Anonymous Referee #3

In this study, the authors compared model-simulated hydrological cycle change in two scenarios: a scenario in which global mean temperature, equator-to-pole temperature gradient, and interhemispheric temperature gradient, are all stabilized at present day level under the RCP8.5 background scenario through stratospheric sulphate aerosol injection (GLENS ensemble simulations); and a scenario in which atmospheric CO<sub>2</sub> is reduced to achieve the temperature stabilization goal of 1.5 degree (carbon capture and storage). The stratospheric sulphate injection simulations are done with CESMWACCM, and the carbon capture and storage simulations are done using CESM1-CAM5. The main metrics used in the analysis are precipitation (P), potential evapotranspiration (PET), and the ratio of P to PET. The regions focused on is North and South America.

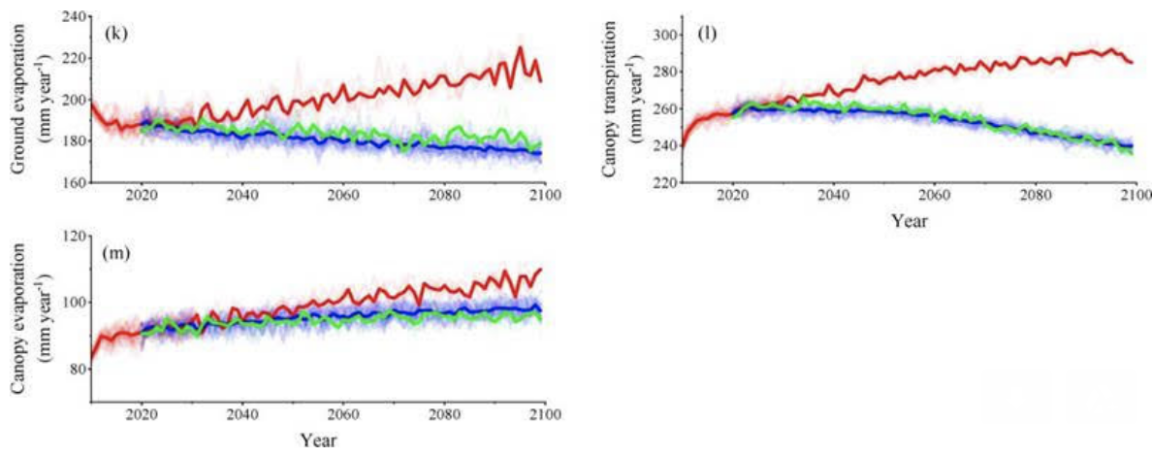
How does the change in PET compare the change in soil moisture as presented by Cheng et al. (2019)?

**In Figures 1 and 2, we had compared P/PET change with soil moisture as studied in detail by Cheng et al., (2019). They are generally consistent but with notable regional differences.**

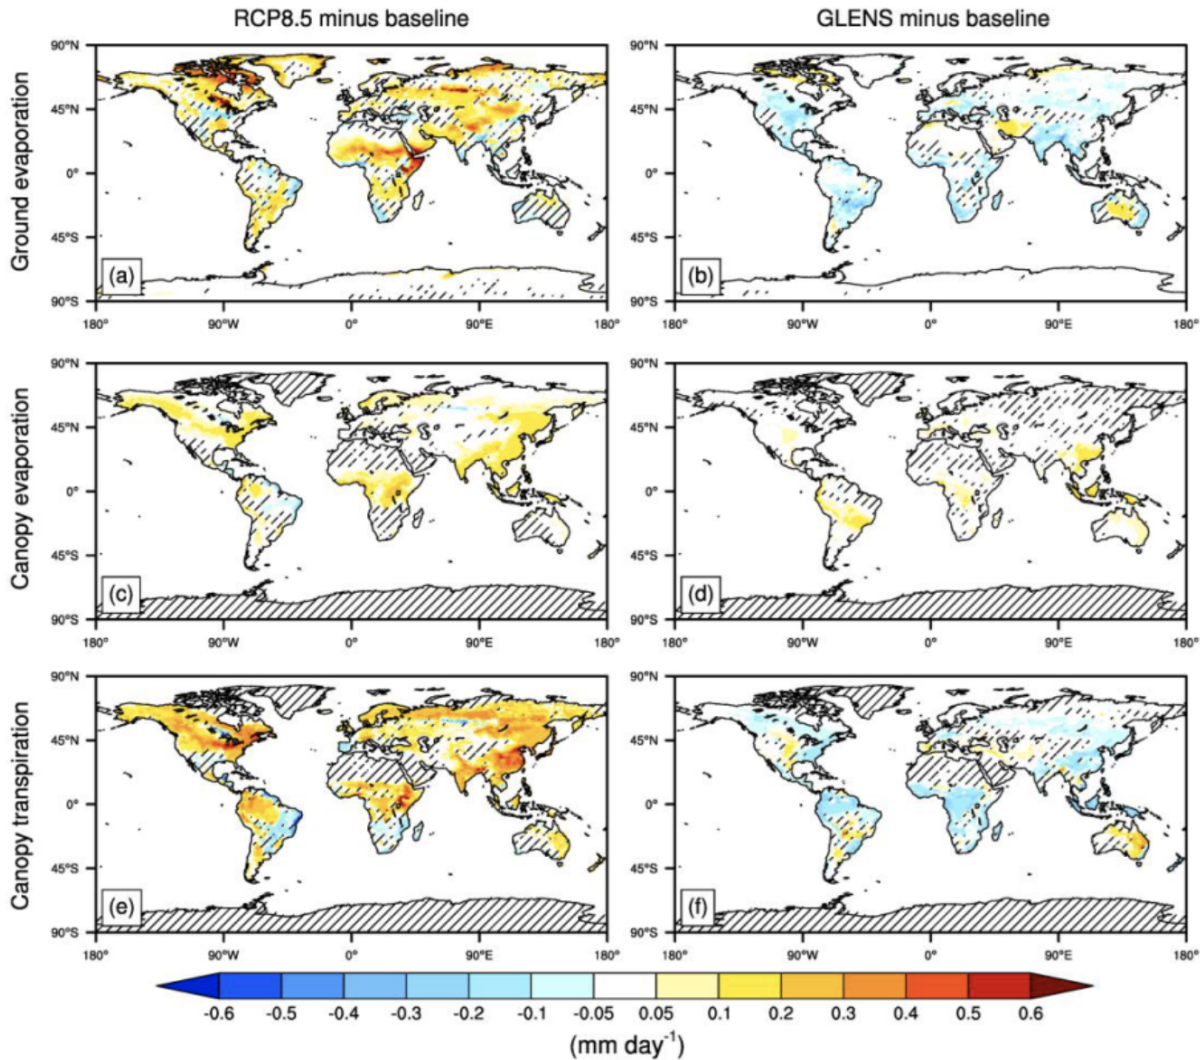
Page, 10, lines 87-88 "For example, the mid-century projected PET increase is 102.2 mm/year, but the Sulfur Injection can lower that by 127.8 mm/year, which drops the absolute value of PET by 25.6 mm/year" 102.2 mm/year is lowered by 127.8 mm/year? Please check the math and expression here.

**The math is correct and actually a point we wanted to make. Sulfur Injection can flip the sign of PET change from increase to decrease.**

**Clarified as "the mid-century projected PET increase is 102.2 mm/year, but the Sulfur Injection can reduce that by 127.8 mm/year, which actually leads to a drop of the absolute value of PET by 25.6 mm/year."**

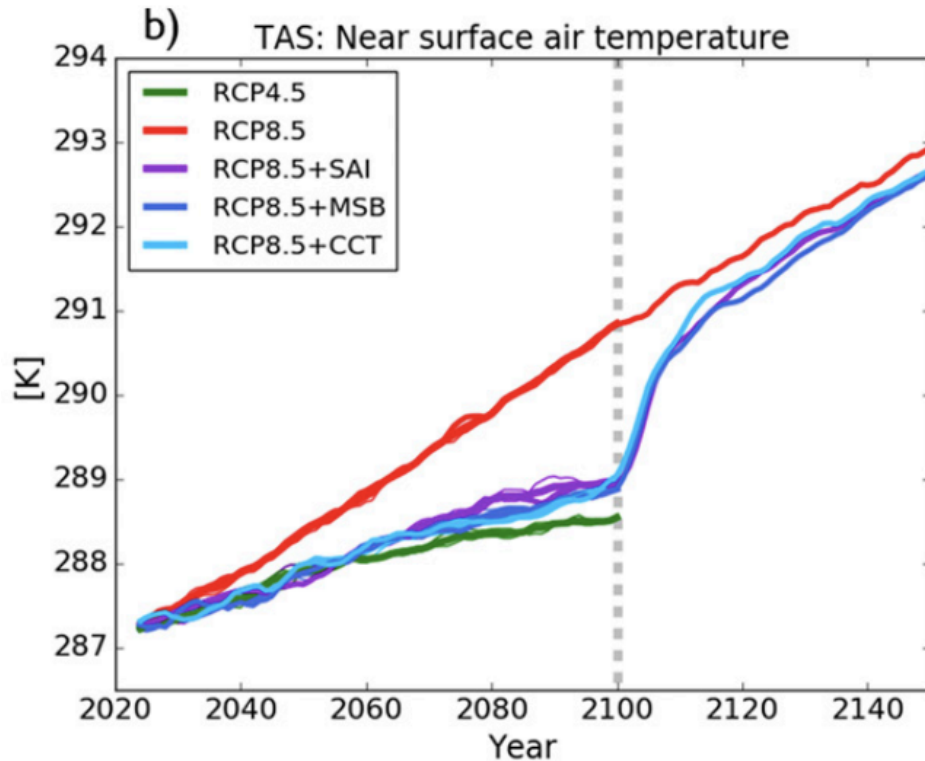
Page 15, lines 50-53: As clearly stated here, there is no direct comparison between GLENS and carbon capture experiment here. First of all, temperature change is not the same, which masks the usefulness of this study.

True. If the experiment were perfectly designed, the temperature change should be maintained the same for both cases to facilitate a fair comparison. We acknowledge the caveat and call for more work into it.

However, retrospectively, we do not really see the temperature level difference of 0.5-1C as a major limiting factor. Several other comparison studies based on climate models are not producing perfectly aligned temperature trajectory either, for example Muri et al., (2018) with Figure 2b copied below. Also see Figure 3 of Niemeier et al., (2013).
